UNITED STATES PATENT AND TRADEMARK OFFICE

APPLICATION NO.	FILING DATE	FIRST NAMED INVENTOR	ATTORNEY DOCKET NO.	CONFIRMATION NO.
10/502,391	07/26/2004	Jong Wook Seo	1751-361	3468

Office Action Summary	Application No.	Applicant(s)	
	10/502,391	SEO ET AL.	
	Examiner	Art Unit	
	Seokyun Moon	2629

DETAILED ACTION

Drawing 1

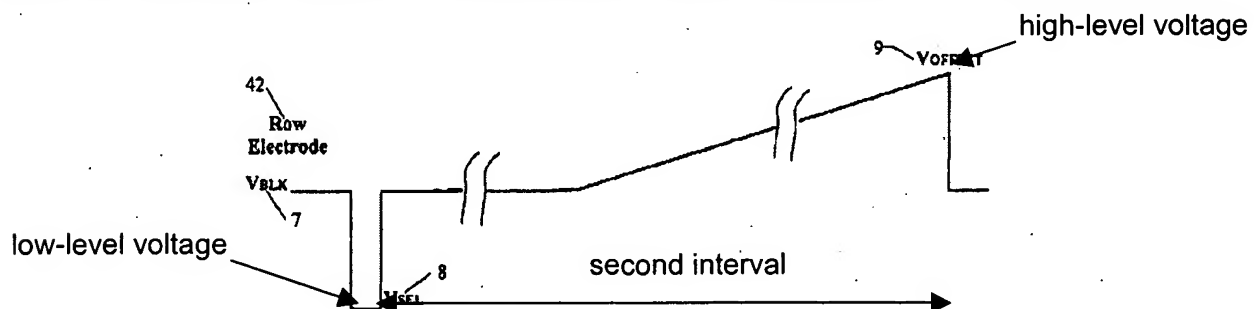
wherein one cycle of the control signal includes a first interval and a second interval, the first interval having a predetermined low-level voltage and the second interval having a high-level voltage obtained by jumping the voltage in the first interval by a predetermined voltage [drawing 1 provided on page 4 of this Office Action, which is equivalent to Rutherford's fig. 3].

As to **claim 3**, Rutherford teaches the voltage in the second interval to be increased by a predetermined rate (the slope of the increasing linear function of the voltage included in the second interval) [drawing 1].
